Tuesday, 24 June 2025
Reference: P191408LT1r2.docm

**Reception Centre, Lot 9002 (1) Hasluck Circuit, North Dandalup –
Acoustic Report Peer Review – Rev 1**

Figure 1 - Forecast $L_{A10,adj}$ music noise in surrounding area

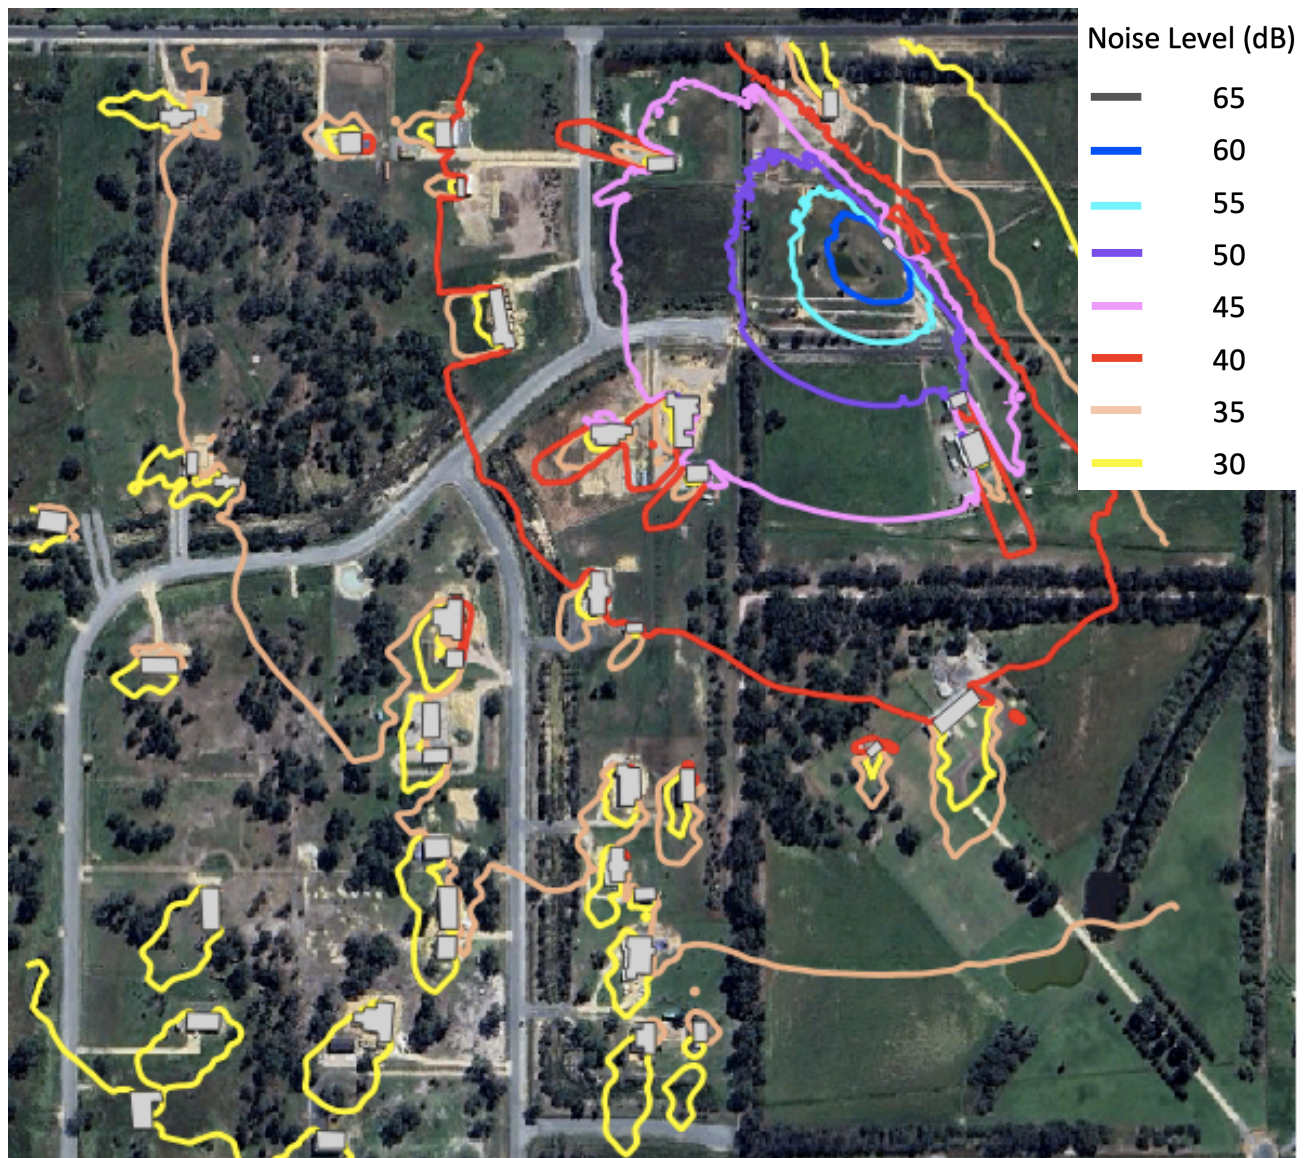
The corresponding free-field $L_{A10, adj}$ music noise at the R3 dwelling was 47 dB. This exceeds the evening assigned level criterion of 40 dB by 7 dB.

The $L_{A10, adj}$ forecast music noise level is also shown in Figure 1 below. This figure shows that the music noise:

Exceeds the evening and Sunday criterion of 40 dB at the four nearest neighbours
Exceeds the night-time criterion of 35 dB at the eleven nearest neighbours

I have not conducted ambient noise monitoring in the area but I remain concerned that the music noise is likely audible at noise levels above 30 dB, especially during the evenings. This music audibility will be shown to result at all twenty neighbouring residences shown in Figure 1.
